**DO: GACH BALL DE CHEANTAR CATHRACH PHORT LÁIRGE
TO: EACH MEMBER OF THE METROPOLITAN DISTRICT OF
WATERFORD**

Re: Section 38 Road Traffic Act 1994 – Active Travel Scheme
PEDESTRIAN & CYCLE FACILITIES IMPROVEMENTS AT THE
FARRONSHONEEN ROUNDABOUT

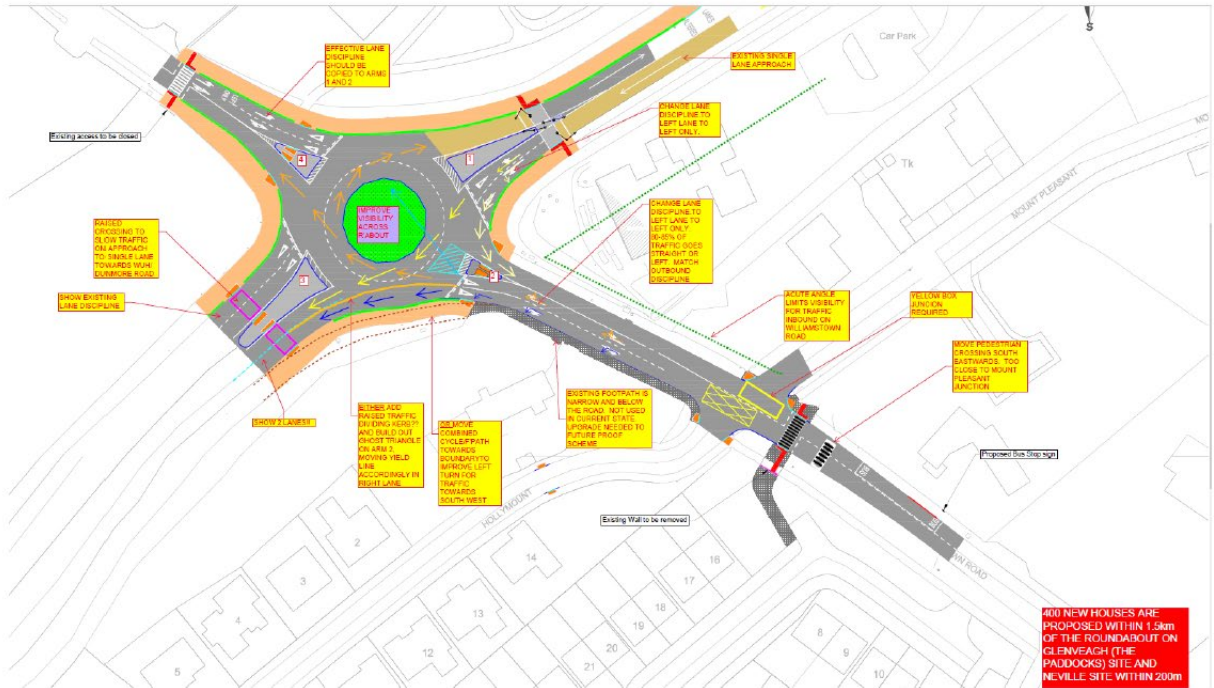
2) In a similar manner changing the lane discipline on the north-eastern arm (Farronsheen arm approach from WUH) would also significantly improve traffic flows. Could one not consider merging SW bound traffic on the ring road as noted on the attached markup by keeping SW bound traffic from WUH/Dunmore Road in the right lane at the roundabout and having the left lane as a left turn only??

3) Has consideration given to improving inbound left turn flows (travelling from South-eastern arm to Southwestern arm) by pushing the combined widened cycle/footpath towards the boundary to the south?

Altering the lane discipline on the R710 eastern arm is not feasible due to the high number of vehicles travelling straight ahead onto the R710 western arm and turning right towards the city. The existing lane discipline on this arm will be retained.

Widening the entry on the Williamstown Road arm and the downstream exit onto the R719 western arm will be considered at detailed design stage.

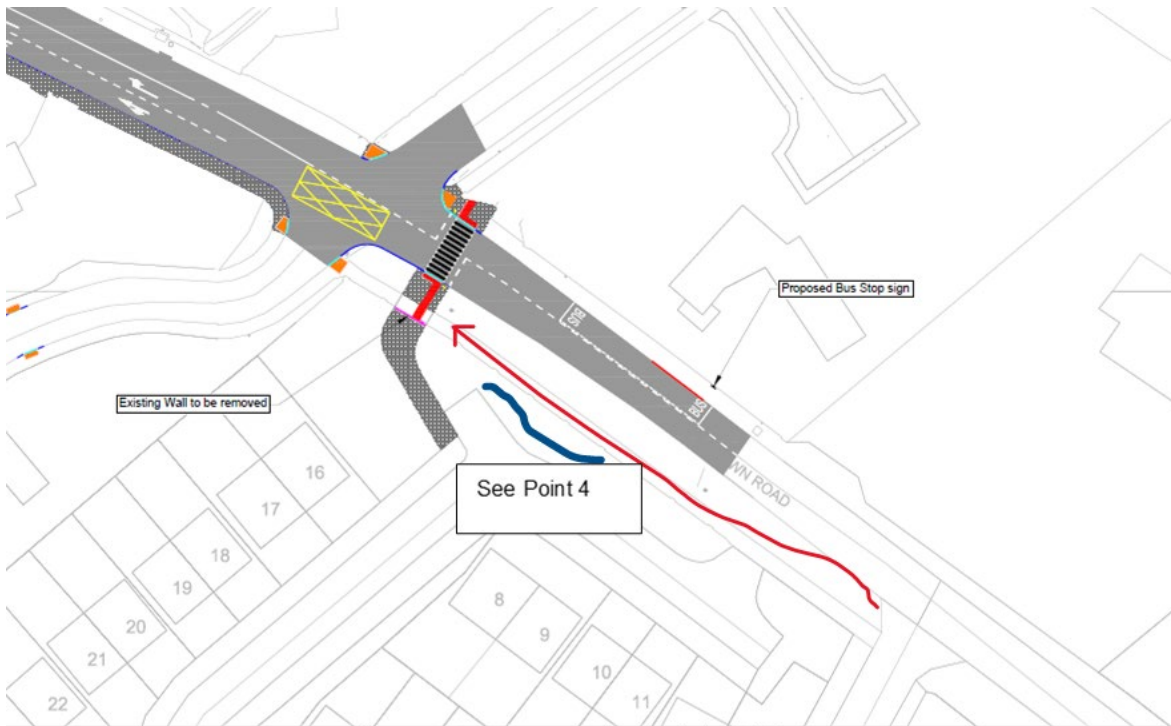
- b. Green area 2 which is where the proposed entrance is planned is completely flat and with the end wall and trees at the entrance acting as a perfect 'soccer' field, it is regularly used by the residents of Mount William and Williamstown Glen throughout the year for this purpose. It is therefore not recommended to open this up to the external roadway and reduce its capacity with a footpath stretched along it.

4. If an entrance is required, then it would make more sense to align this to the existing footpath structures and reduce the cost of the works and also the size and security impact on Green Area 2. An entrance by the parking area would make more sense where the existing footpaths end.

Having reviewed submissions in relation to the scheme, we are proposing to amend the location of the proposed footpath to 'wrap around' the existing hammerhead/parking bay and connect to an existing pier on the boundary wall.

We will also construct a low-level wall along the footpath and plant new trees behind this wall. This should create a more secure feeling for users of the Green. We envisage the removal of one existing tree, subject to final detailed design.
